Your Ref  
APP/16/00167  
Our Ref  
PLAN-013134  
Date  
09/03/2016

**Proposal: Remove conservatory and bay windows. Internal and external alterations, raised terrace and erection of car port and store building.**  
**Site: Broad Oak, Copse Lane, Hayling Island, PO11 0QB.**  
**APP/16/00167.**

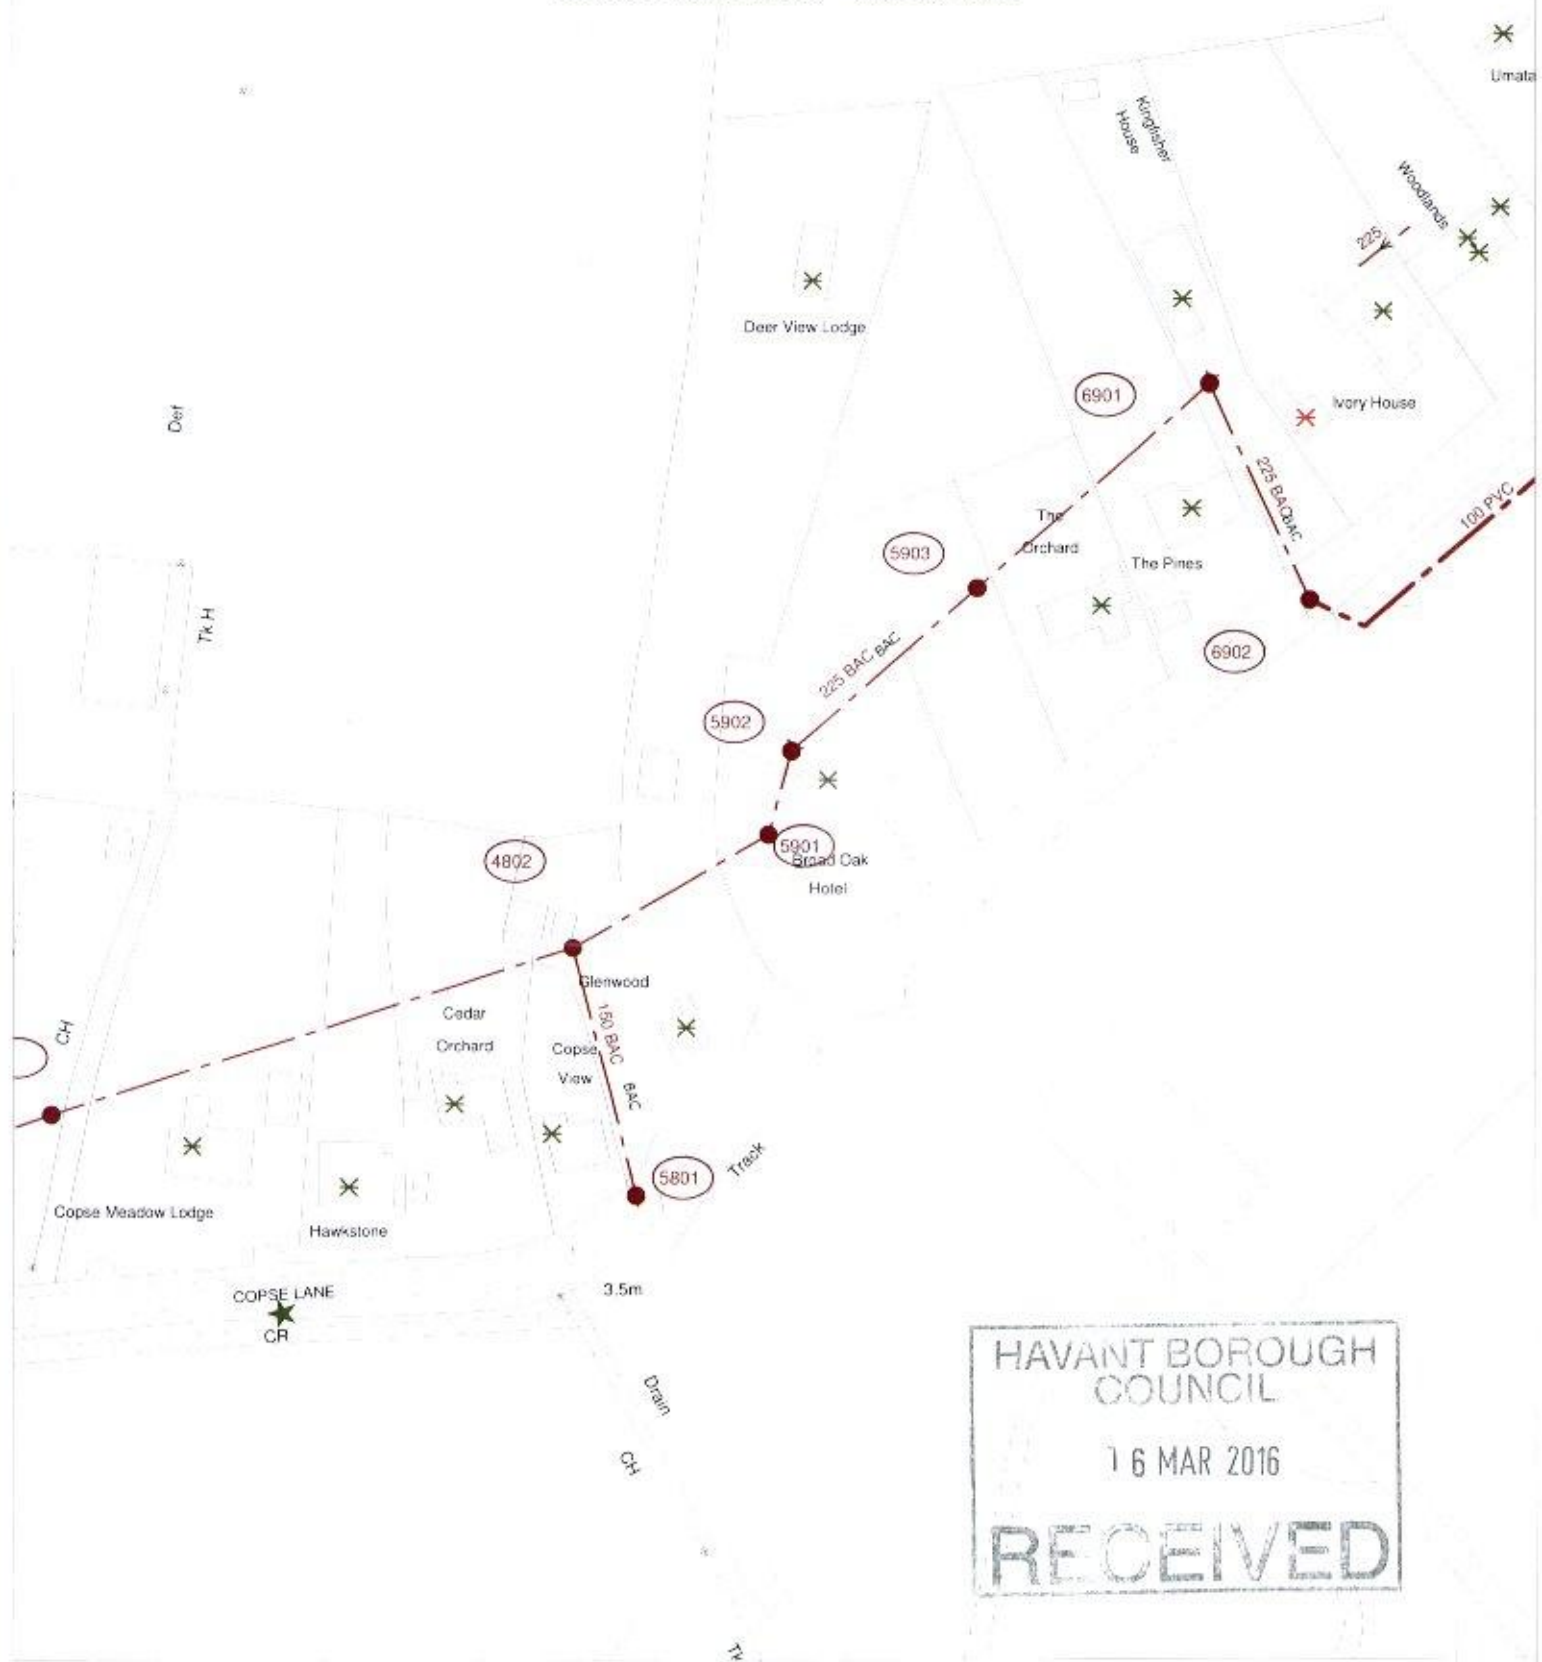
Please find attached a plan of the sewer records showing the approximate position of a public foul sewer with in the proposed development. The exact position of the public foul sewers must be determined on site by the applicant before the layout of the proposed development is finalised.

It might be possible to divert the public foul sewer, so long as this would result in no unacceptable loss of hydraulic capacity, and the work was carried out at the developer's expense to the satisfaction of Southern Water under the relevant statutory provisions.

1. The 225mm diameter sewer requires a clearance of 3 metres either side of the sewer to protect it from construction works and allow for future access for maintenance.
2. No development or new tree planting should be located within 3 metres either side of the centreline of the public sewer
3. No new soakaways should be located within 5 metres of a public sewer.
4. All other existing infrastructure should be protected during the course of construction works.

Alternatively, the applicant may wish to amend the site layout, or combine a diversion with amendment of the site layout. If the applicant would prefer to advance these options, items (1) – (4) above also apply.

In order to protect drainage apparatus, Southern Water requests that if consent is granted, a condition is attached to the planning permission. For example "The developer must advise the local authority (in consultation with Southern Water) of the measures which will be undertaken to divert the public sewers, prior to the commencement of the development."
